URGENT: MEDICAL DEVICE CORRECTIVE ACTION

SINGLE USE LIGATING DEVICE

Product Name	Model/Catalog Number	Manufactured Date Range	UDI
SINGLE USE LIGATING DEVICE POLYLOOP	HX-400U-30	22-Sept-2022- 7-Sept-2025	04953170368615

Date: 3-NOV-2025

Figure 1

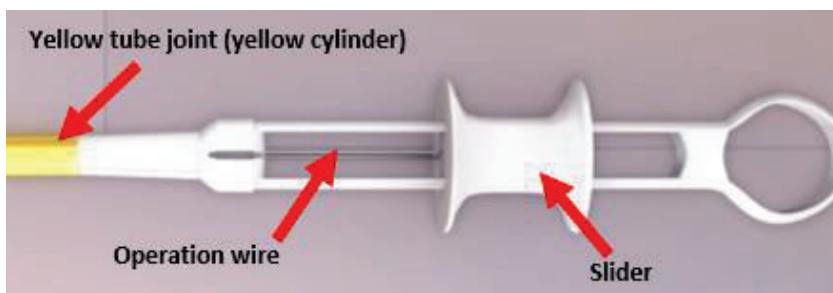
- Inadvertent or intentional movement of the yellow tube joint (cylinder) away from the device handle during use. Intentionally moving the yellow tube joint away from the handle to prematurely tighten the loop during use may cause the inability to release the ligation loop. (See figure 1 below.)
- Forceful advancement of the slider located on the device handle when resistance is encountered may cause an inability to release the loop.

- b) When operating the yellow tube joint (yellow cylinder), be careful not to move it away from the handle, prematurely tightening the loop which may cause the inability to release the ligation loop.

Figure 2.

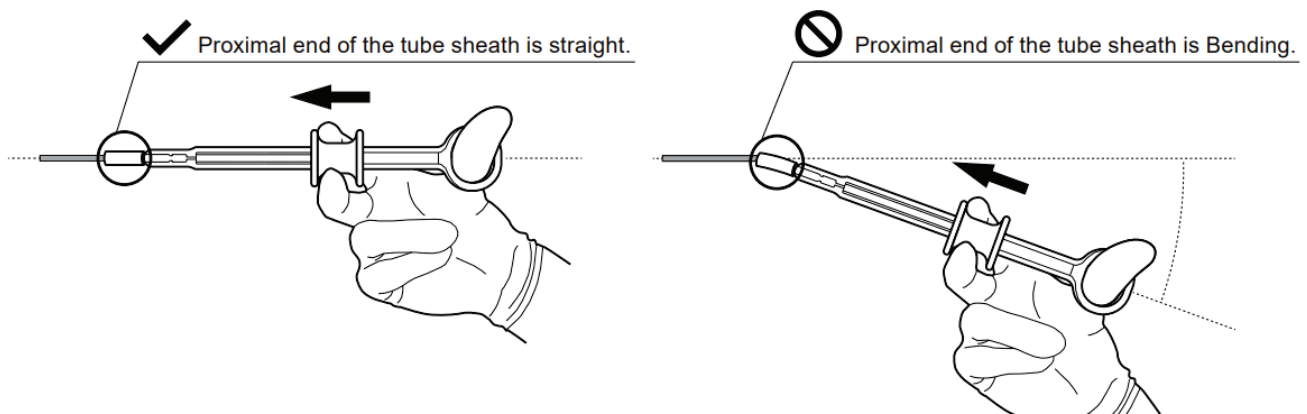
- To detach the loop, ensure the proximal end of the tube sheath and the handle remain straight and aligned with the forceps (biopsy) valve of the endoscope. Then, push the slider as shown in Figure 2. Avoid bending the proximal end, as this increases frictional resistance and may lead to breakage of the operating pipe when the slider is pushed. In this case, refer to Section 12, “Emergency Treatment” and as shown “Equipment meant to be used in an emergency” in the IFU manual.

Figure 3.

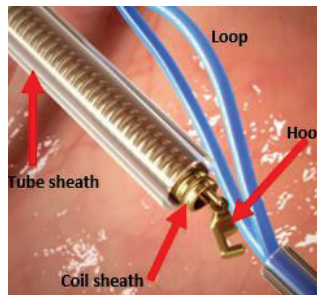
NOTE: See Figures 1 and 3 for device image and components described within this document.

- Prepare and inspect the instrument as instructed, should any irregularity be observed, (i.e., deviation or crushed distal end of the coil sheath), do not use the instrument as it may not be possible to detach the loop from the instrument; use a spare instead.
- Never use excessive force to operate the instrument.
- Always have a spare instrument available.
- Always have the Olympus loop cutter (FS-5L/Q/U-1) (FS-410L/U), pliers and/or wire cutters ready to cut the coil sheath, tube sheath and operation wire (See Figure 1 above) in case the loop cannot be detached from the instrument.
- If the loop cannot be detached from the instrument, do not forcibly withdraw it from the endoscope; (doing so could cause patient injury such as punctures, hemorrhages or mucous membrane damage). Follow the emergency procedures described in Section 12 of the IFU. See appendix 1 of this letter.

- Do not remove the loop from the hook while the coil sheath is not extended from the tube sheath. Otherwise, the loop may be tangled with the hook and become impossible to remove. In this case, refer to Section 12, “Emergency Treatment” and “Equipment to be used in an emergency” in the IFU manual.
